DANE COUNTY DEPARTMENT of PUBLIC WORKS, HIGHWAY and TRANSPORTATION

RFB NO. 313083 - ADDENDUM NO. 3

CONSTRUCTION OF EAST HIGHWAY GARAGE – SALT STORAGE FACILITY (BID PACKAGE A) AND MEDICAL EXAMINER OFFICE BUILDING (BID PACKAGE B)

**DEPARTMENT OF PUBLIC WORKS,
HIGHWAY & TRANSPORTATION
3562 COUNTY HIGHWAY AB
MCFARLAND, WISCONSIN**

Sheet A-402 – Wall Sections

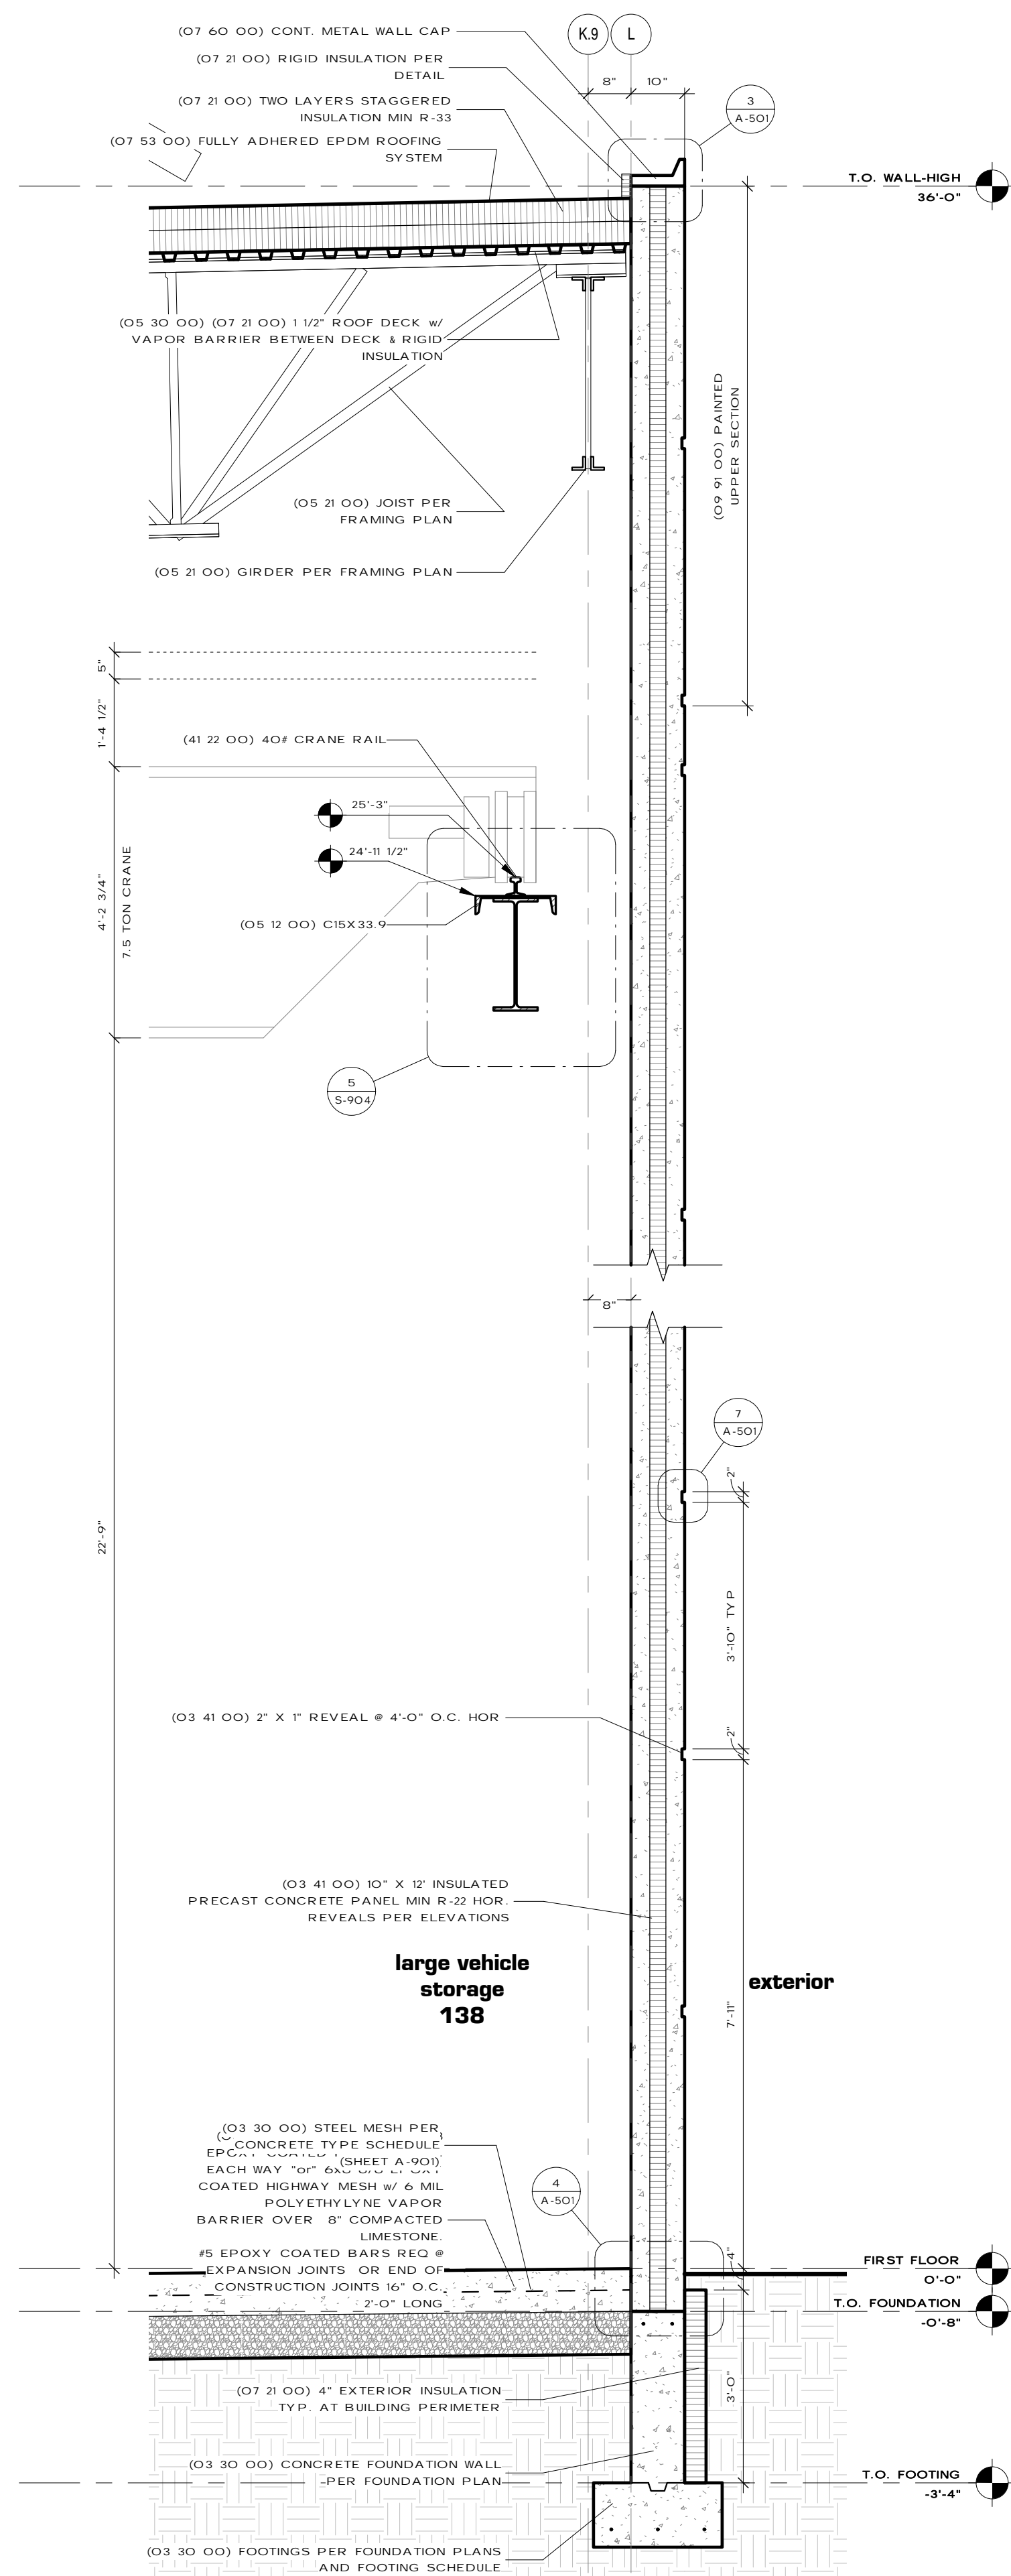
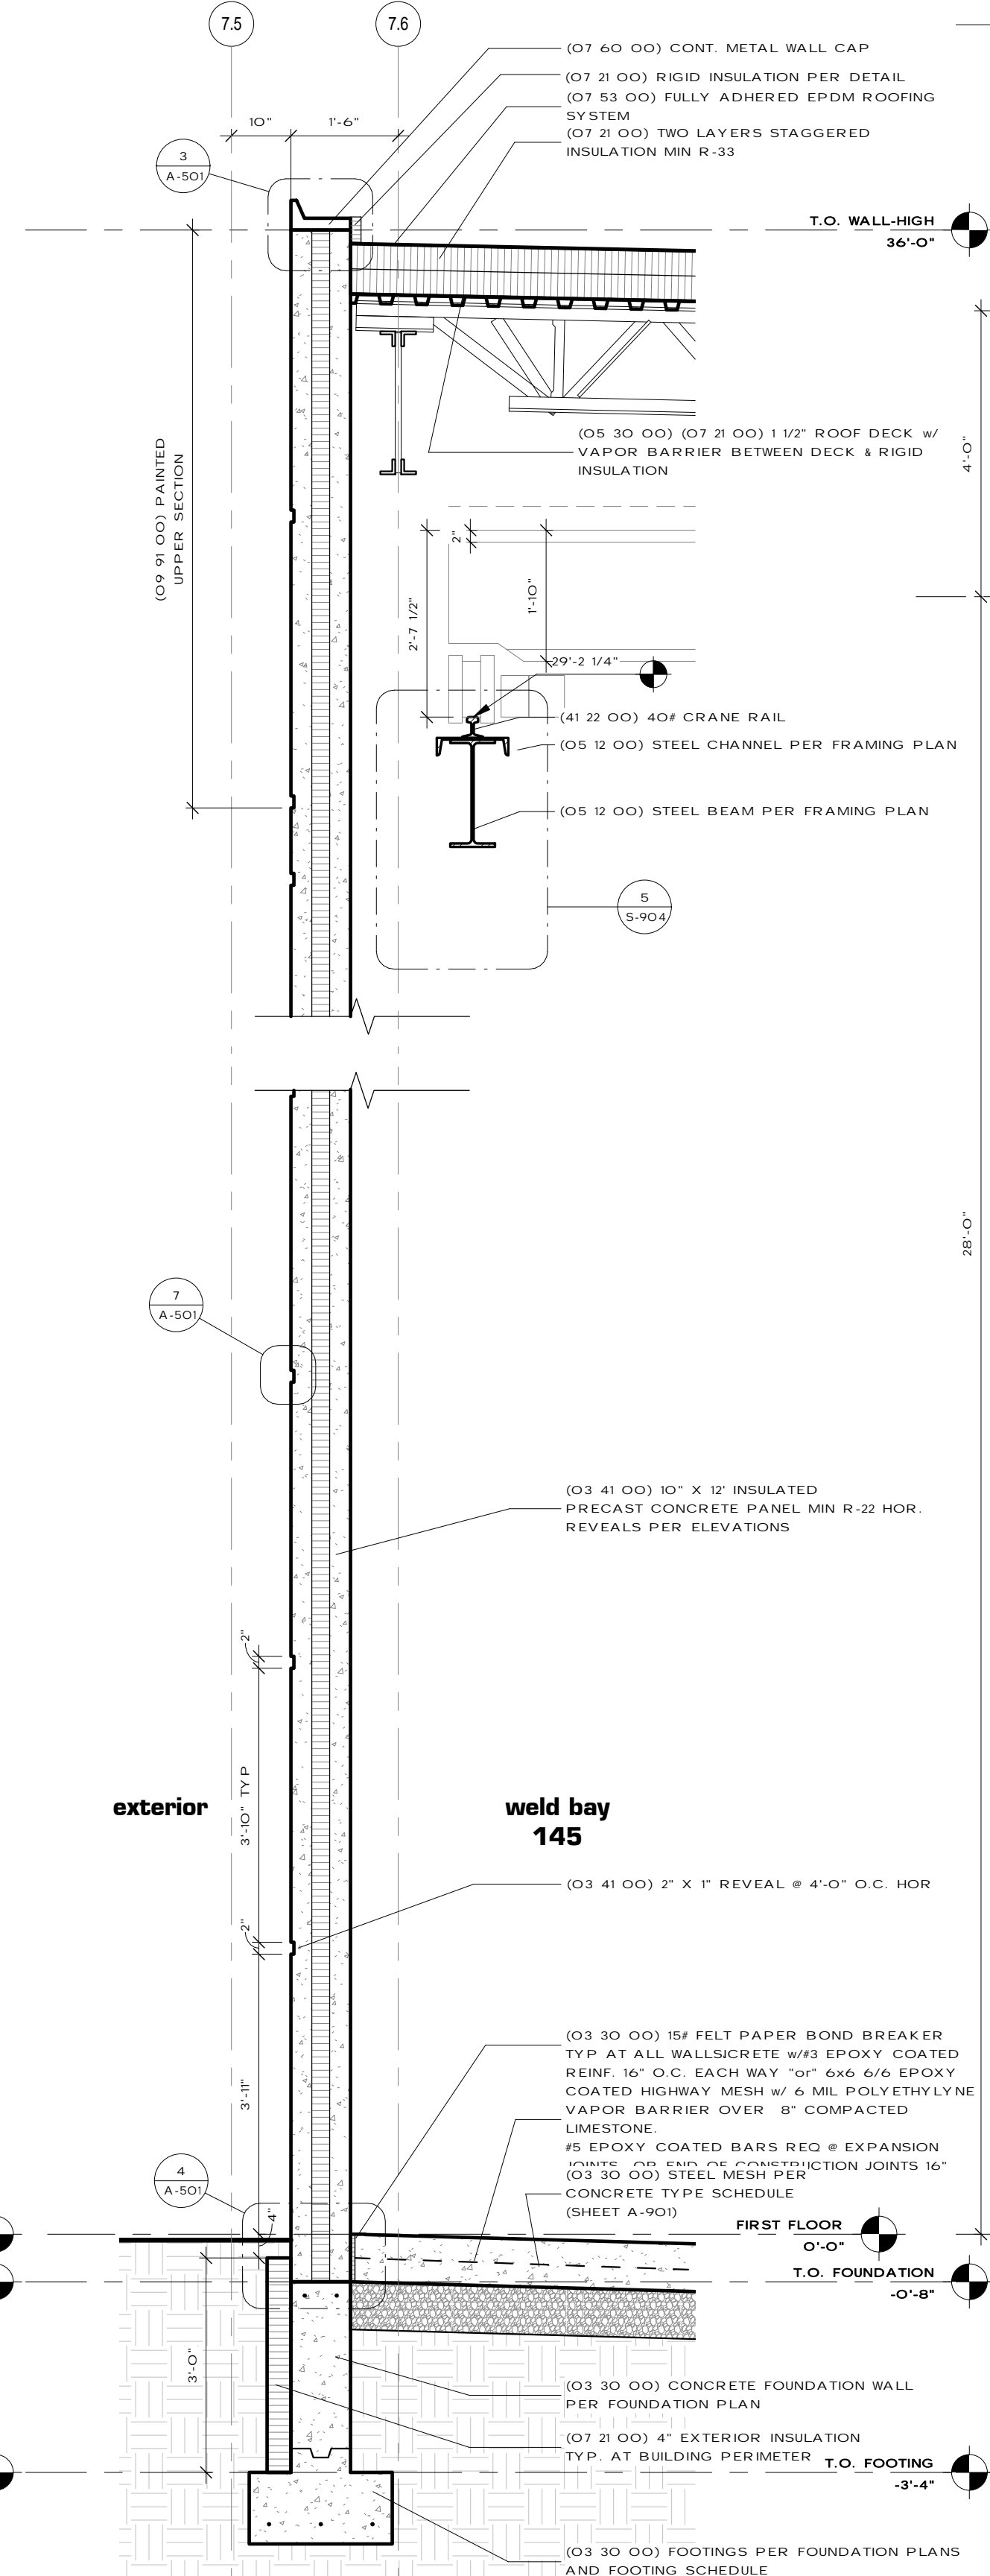
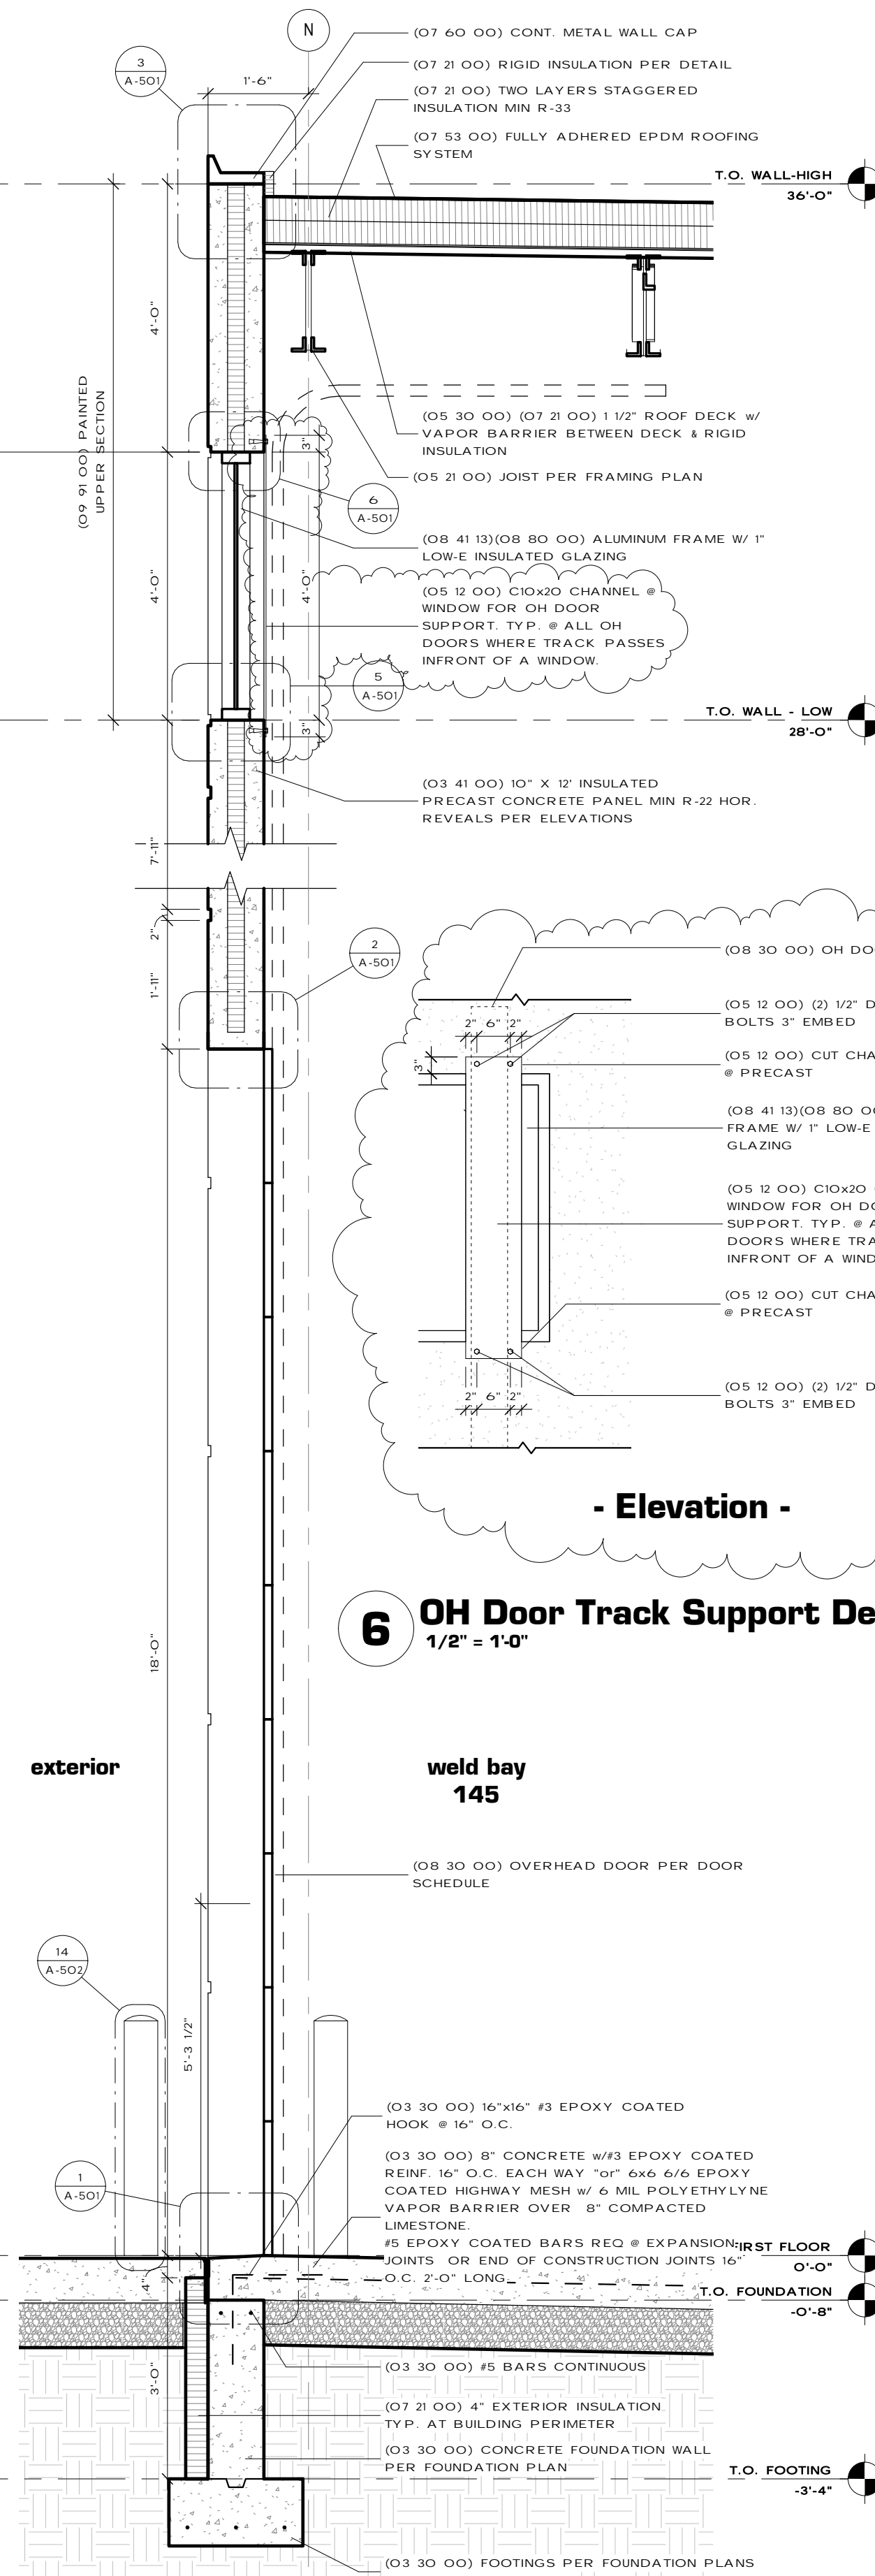
1. Detail 3 – Wall Section. See added detail to this sheet for steel support of sectional door track. See revised sheet included in this addendum.
2. Detail 6 – Added detail for steel support of sectional door track. This detail occurs wherever sectional door track passes in front of a window. See revised sheet included in this addendum.
